ORIGINATION FORM

Proposed Revisions to a Standard Plans Index
(Please provide all information – Incomplete forms will be returned)

Index Number: **00518**
Sheet Number (s): 1 of 2
Index Title: Shoulder Rumble Strips

Revised entire Index. New name of Index is Ground-In Rumble Strips.
Sheet 1: Deleted Shoulder Ground-In Rumble Strip Placement Detail. Revised General Notes. Changed Shoulder Ground-In Rumble Strips Detail and Arrays Detail.
Sheet 2: Deleted Sheet.

SHOULDER GROUND-IN RUMBLE STRIP PLACEMENT

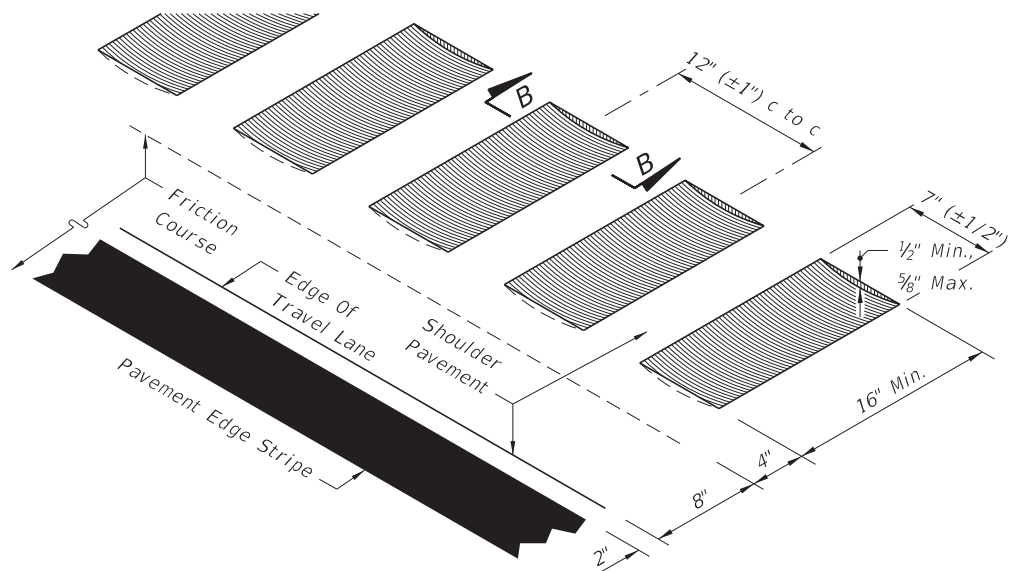
Moved to FDM
